Product Change Notice

- Products : LM301B (SPMWHD32AMD*****)
CCTs : 27/30/35/40/50/57/6500K
- Change : Changed Chip version
- Remark : Change implemented after approval

1. Overview

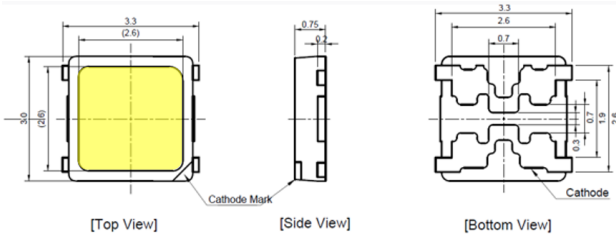
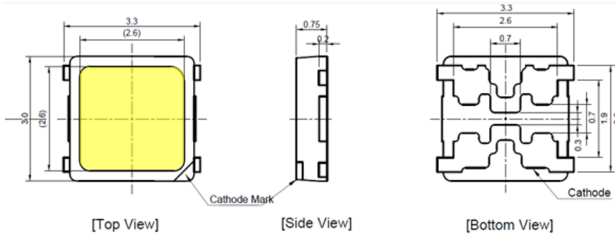
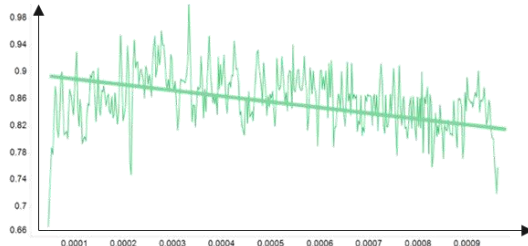
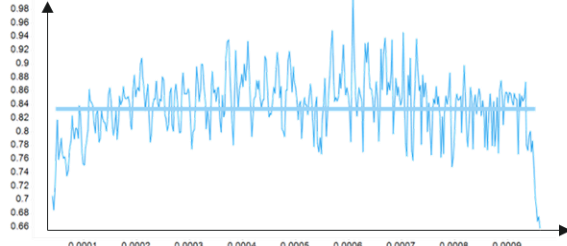
■ Overall performance and reliability stay the same

Change (Before vs. After)	Remark
Material	L/F	Same as before	PCT
	Chip	Half dot → Full dot (Electrode shape change)	Same
Electrical Performance		Same as before	-
Mechanical		Same as before	-
Beam angle		Same as before	-
Electrical Characteristics		Current spreading improved	Expand Current Spreading Area Chip IQE (Internal Quantum Efficiency) ↑
Radiating Characteristics		Increasing about 1%	
Image

3-1. Sweep Performance

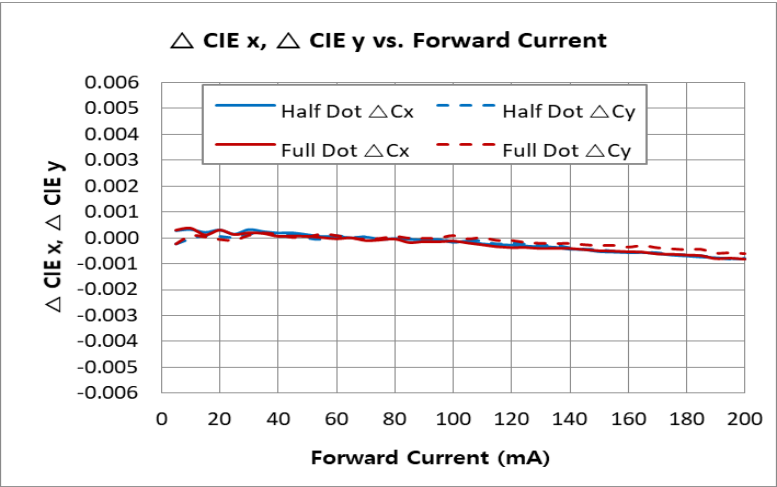
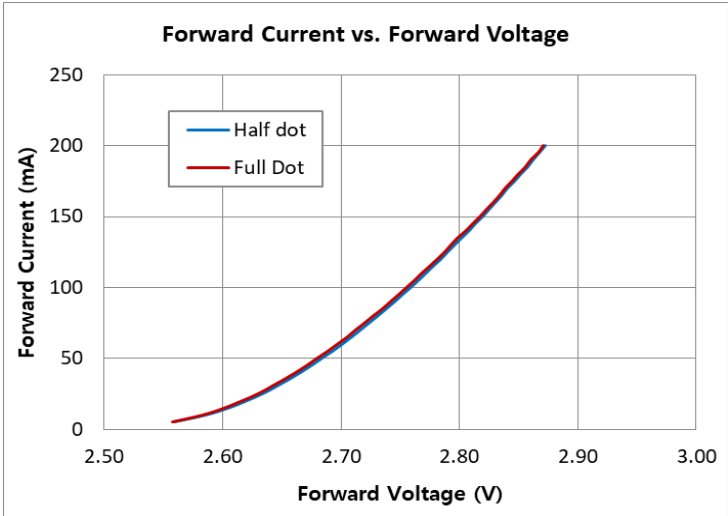
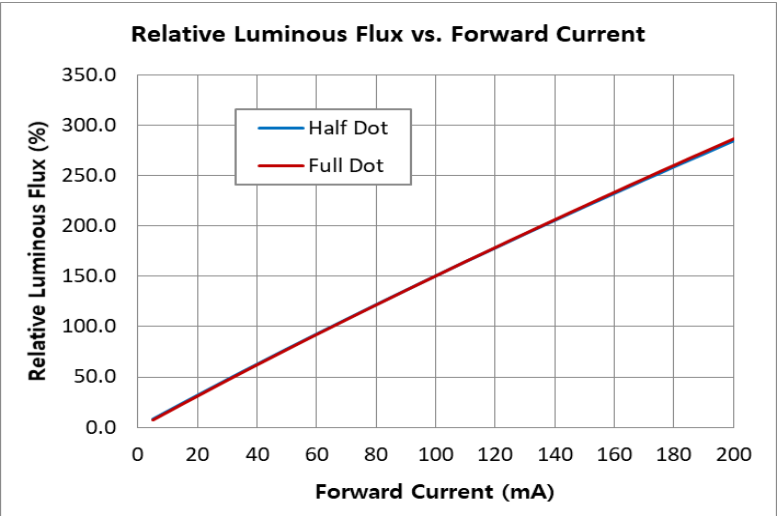
■ No change Characteristics with Current sweep

3-2. Temperature Performance

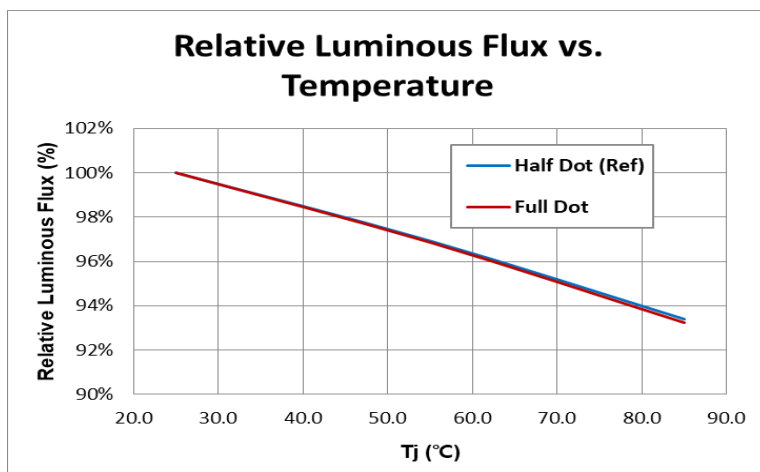
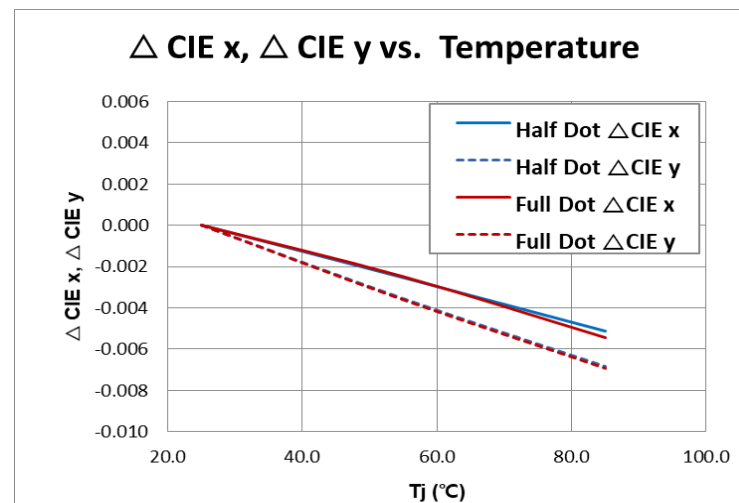
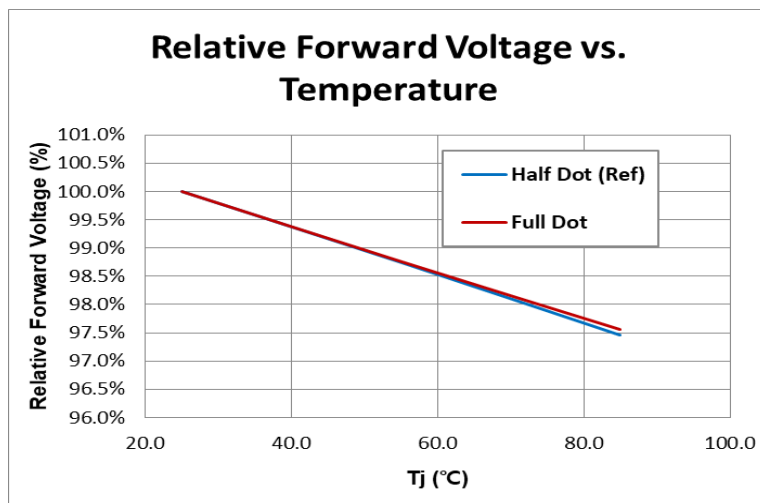
■ No change Characteristics with Temperature

3-3. Optical Performance

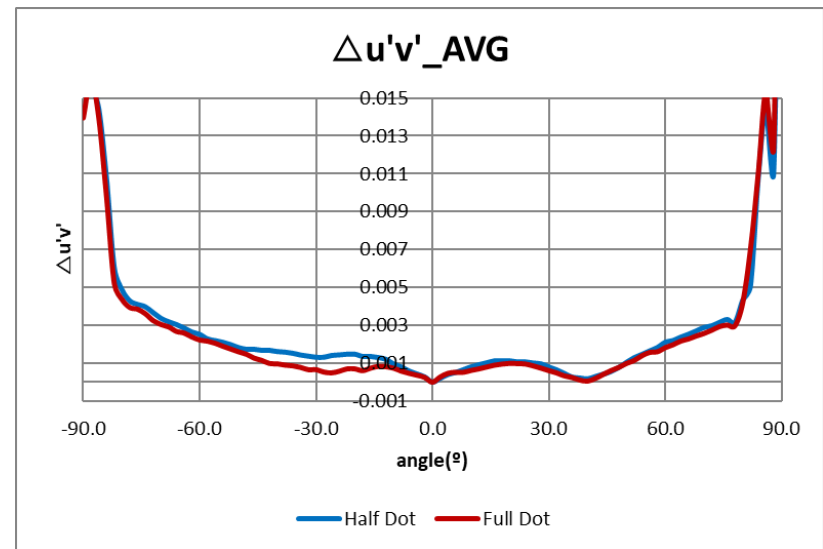
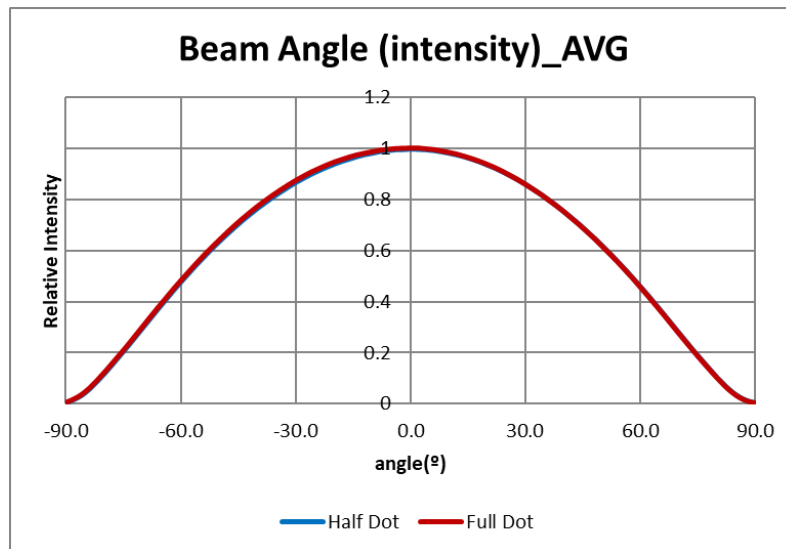
■ No change Optical Characteristics
